Southern Nuclear Operating Company
Vogtle Early Site Permit Application
Supplemental Response to Requests for Additional Information on Geology/Seismology

Supplemental Response to Geology/Seismology RAIs

Vogtle ESP Application

Figure 1a. Quadratic fit to the amplification values for 100 Hz.

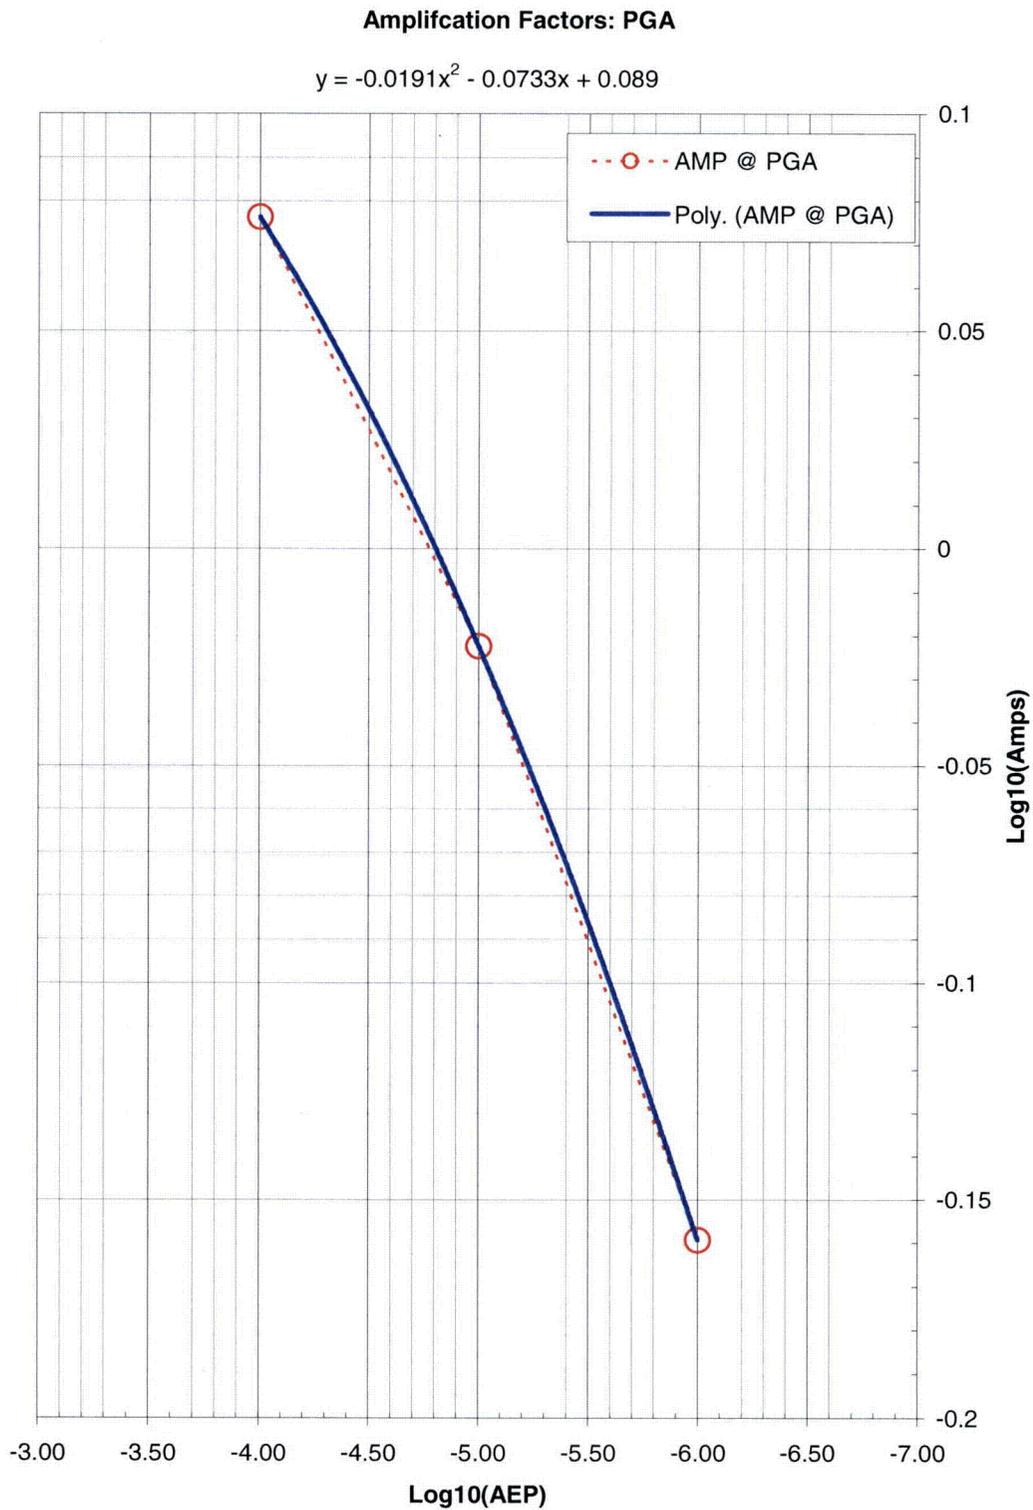
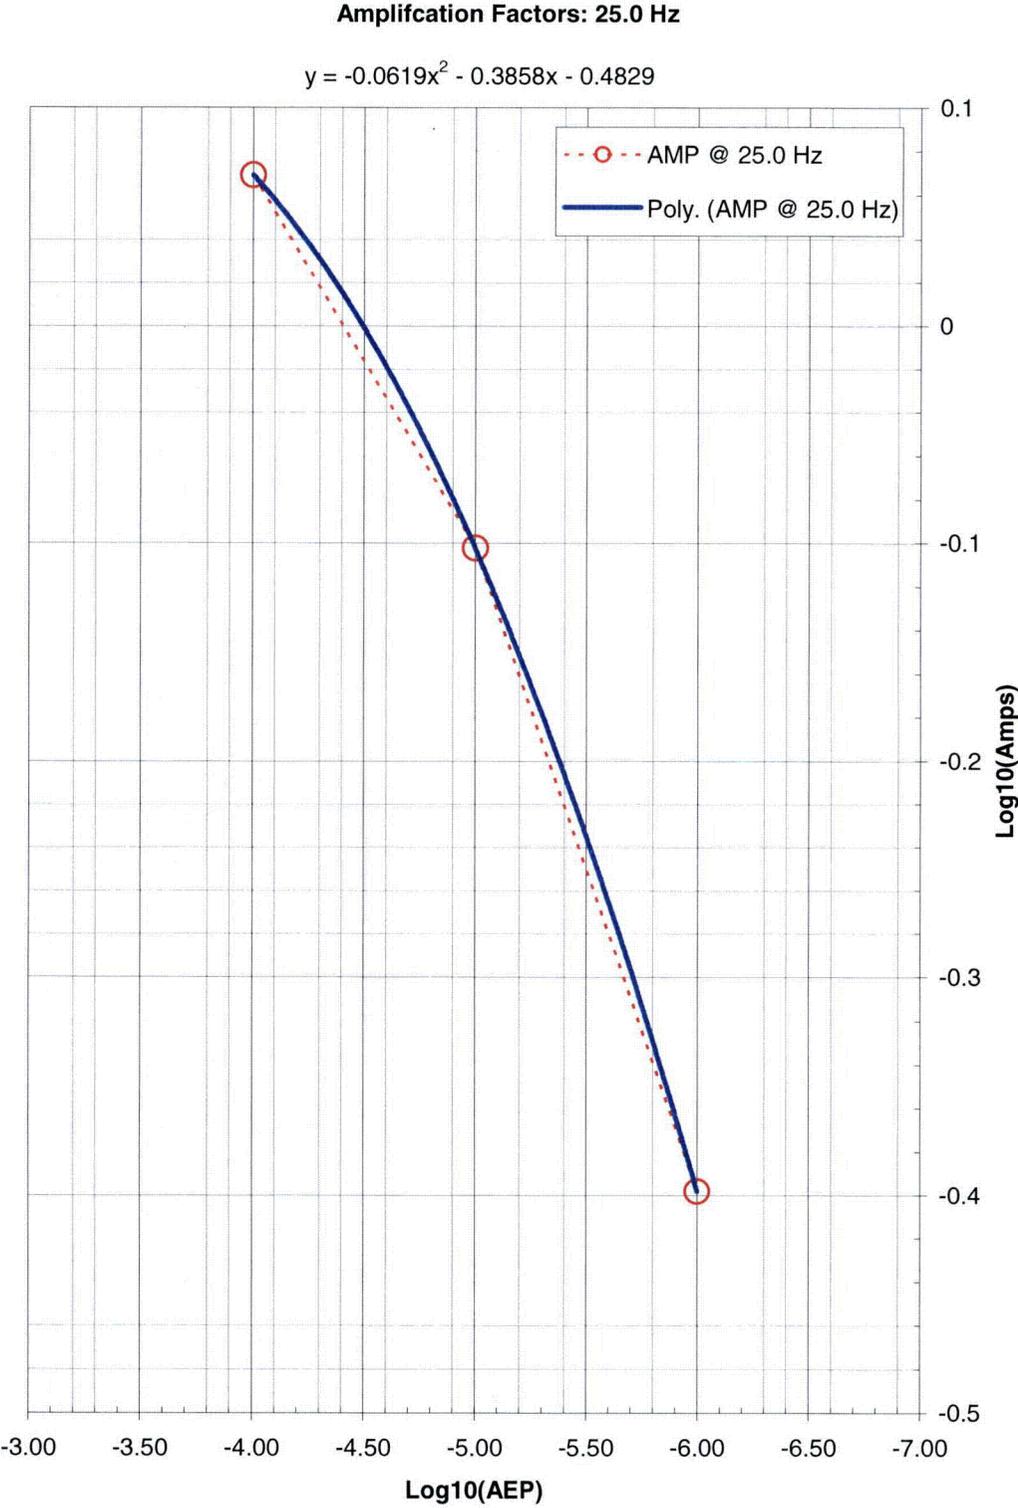
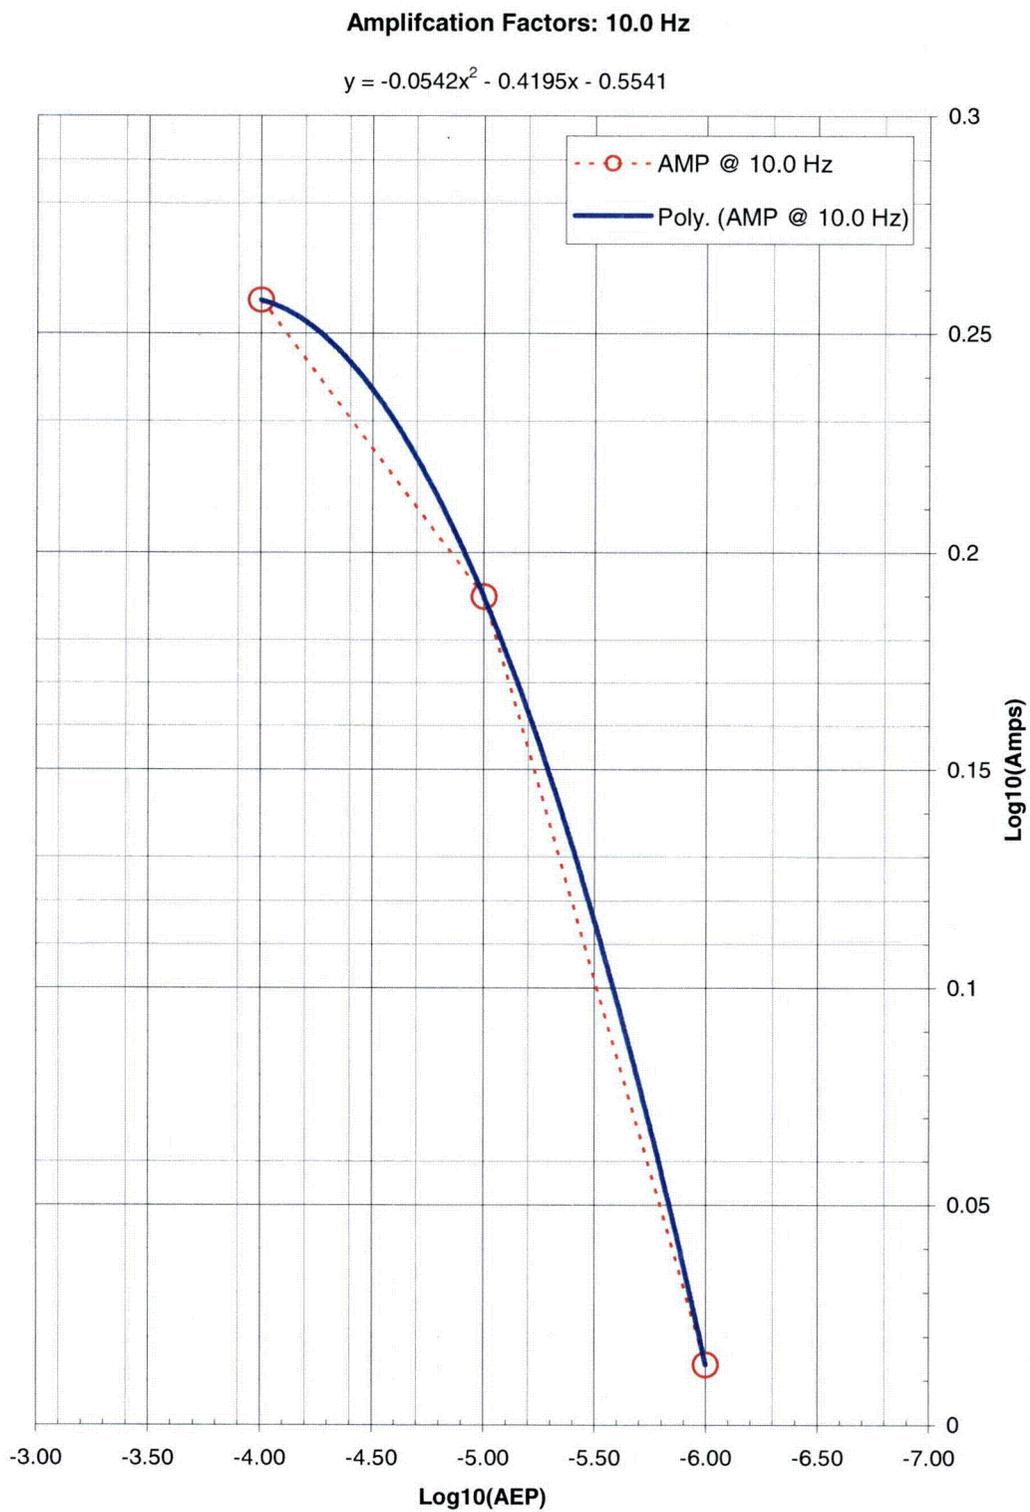
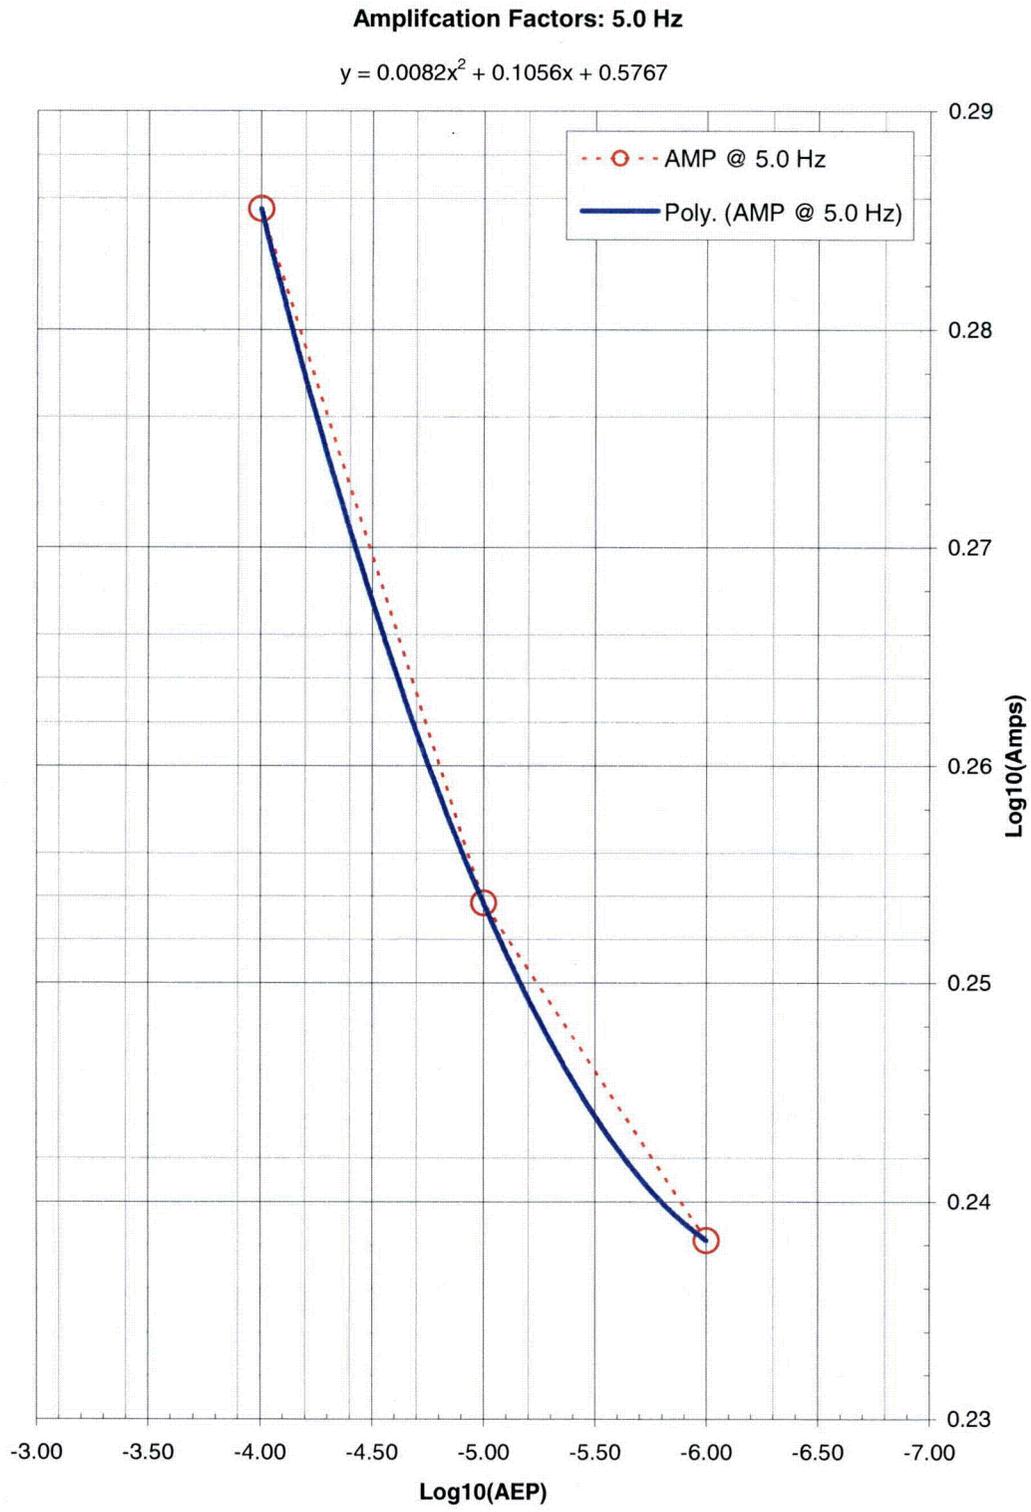
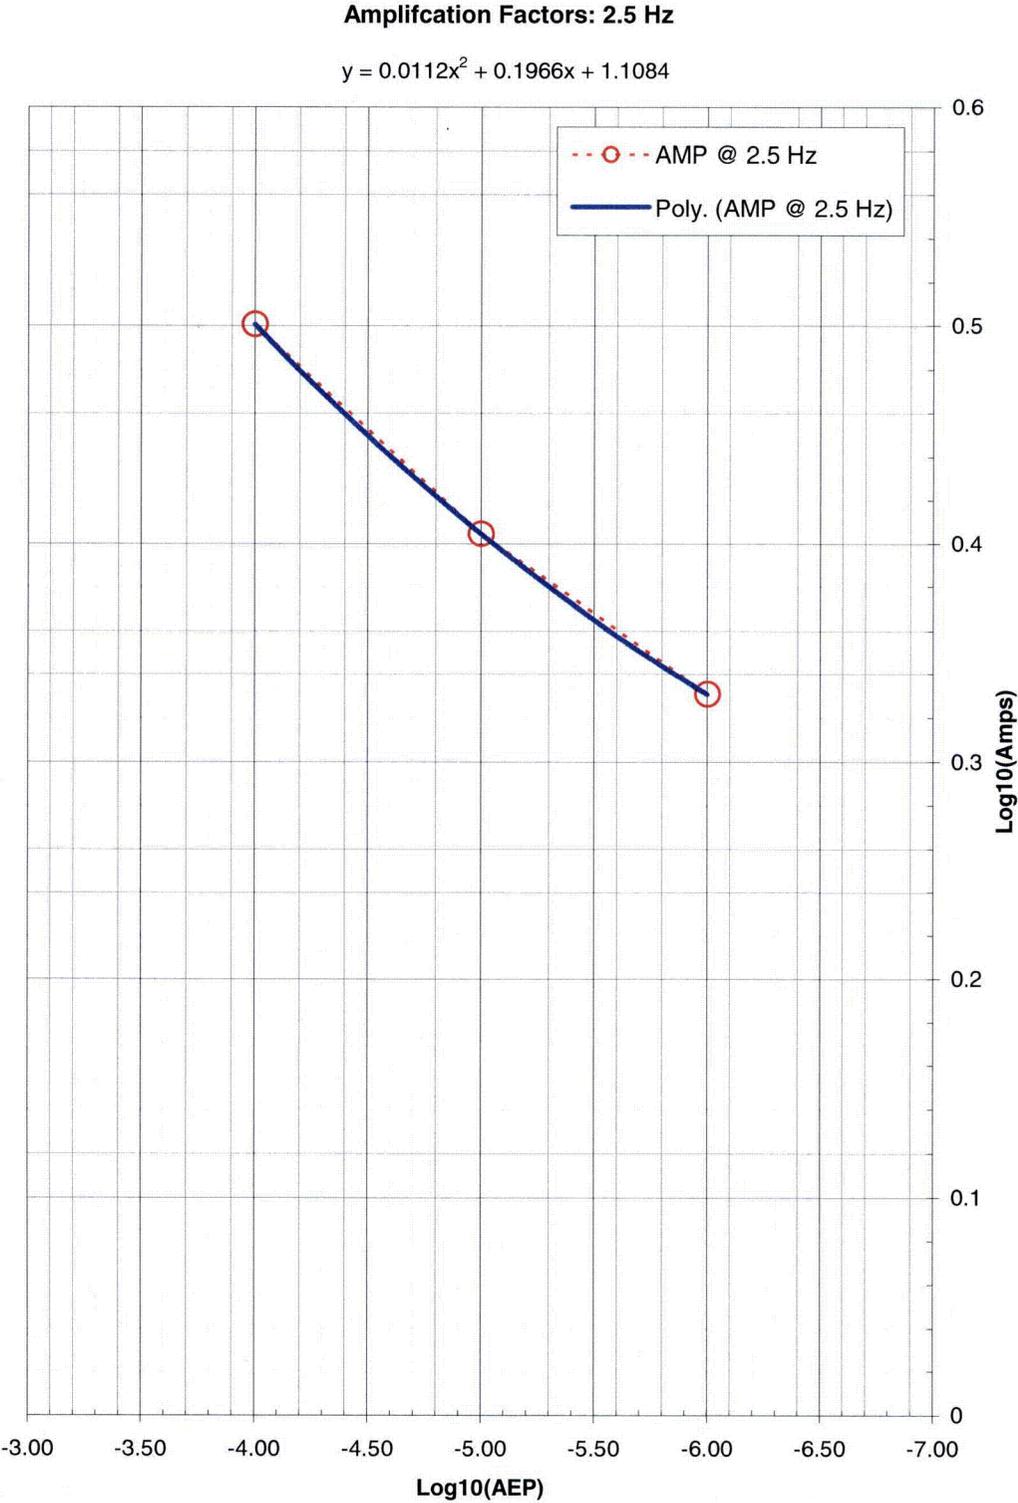
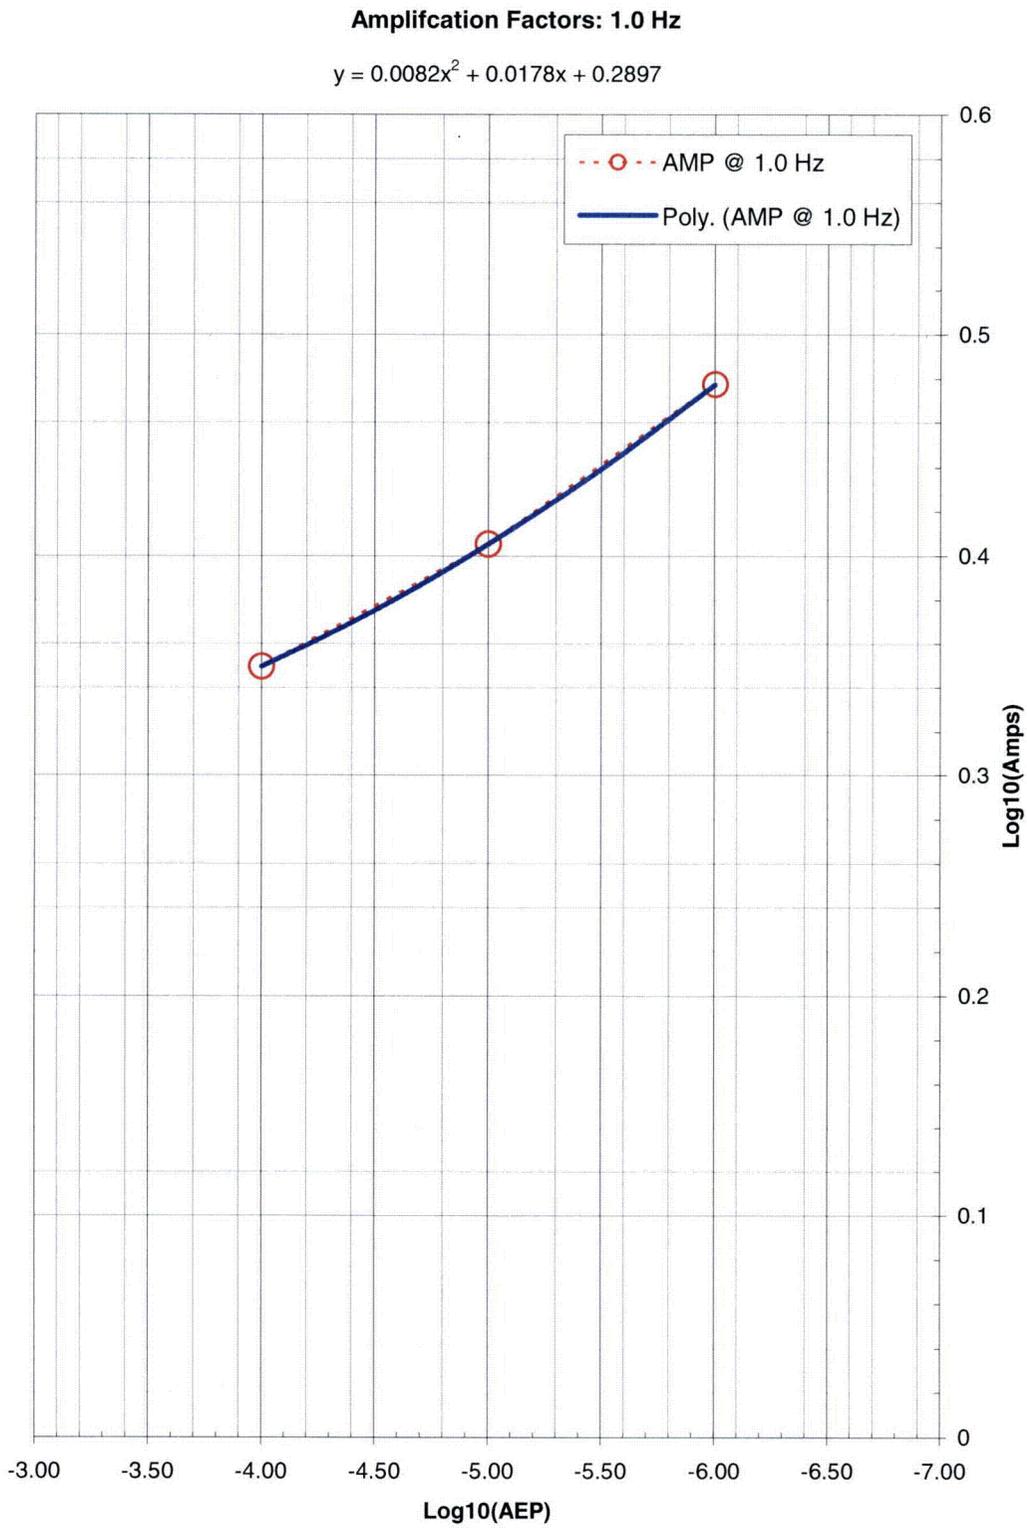
2.5.2-3 In response to this RAI, soil hazard curves were provided at three annual exceedence frequencies (10^{-4} , 10^{-5} , and 10^{-6}). However, in order for the staff to verify the adequacy of the SSE, soil hazard curves are requested at additional annual exceedence frequencies (i.e. at values between 10^{-4} , 10^{-5} , and 10^{-6}).

For each of the seven frequencies a quadratic equation was fit to the log (base10) of the spectral ratios (AMP) as a function of the log (base10) of the annual exceedence probability (AEP). Mathematically, this functional model is given as,

The resulting fits to the three data points are shown in Figure 1, located on the following pages, for each of the seven frequencies. The coefficients and equation are given at the top of each plot. Note that the red dashed line is a linear log-log line between the three data points.
